Reference number: TR010032  
Document reference: TR010032/EXAM/10.46

## **A122 Lower Thames Crossing (Reference Number TR010032)**

### **1 Applicant's further planned amendments**

**Figure 1: proposed update to the Land Plans**

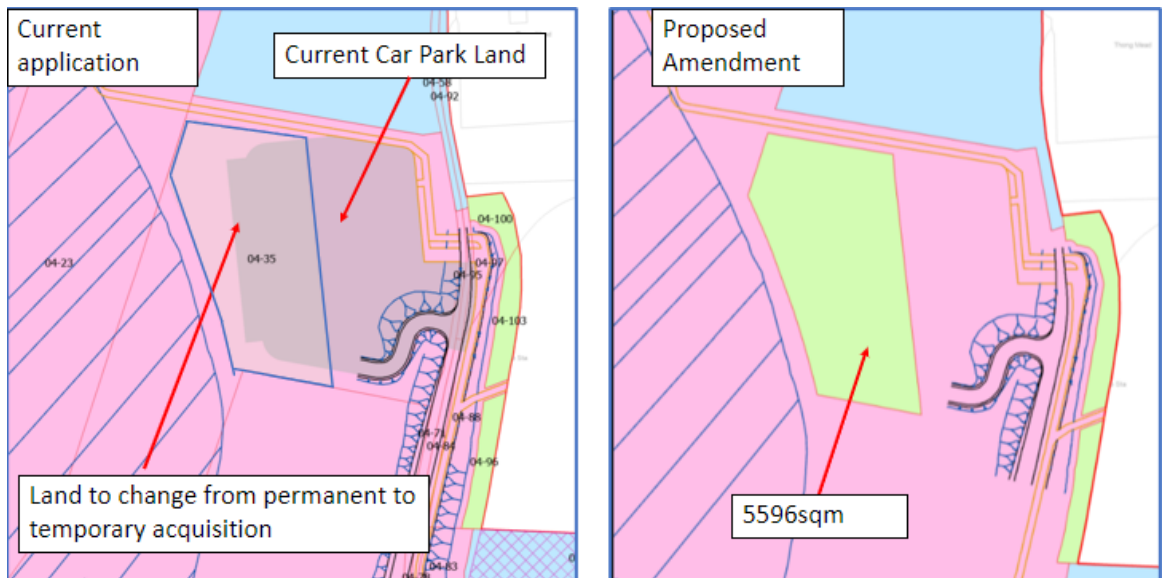
1.2.3 In response to concerns expressed by stakeholders in relation to the potential effects of recreational facilities (as expressed at ISH9 and through stakeholder engagement), the Applicant intends to remove the car park proposals (i.e. Work No. 1P) from the Application on a precautionary basis.

1.2.4 Removing the car park would enable an area of mitigation planting to be relocated further east with a circa 5,600sqm area changed from requiring permanent acquisition to temporary possession of land only as shown on Figure 1 below:
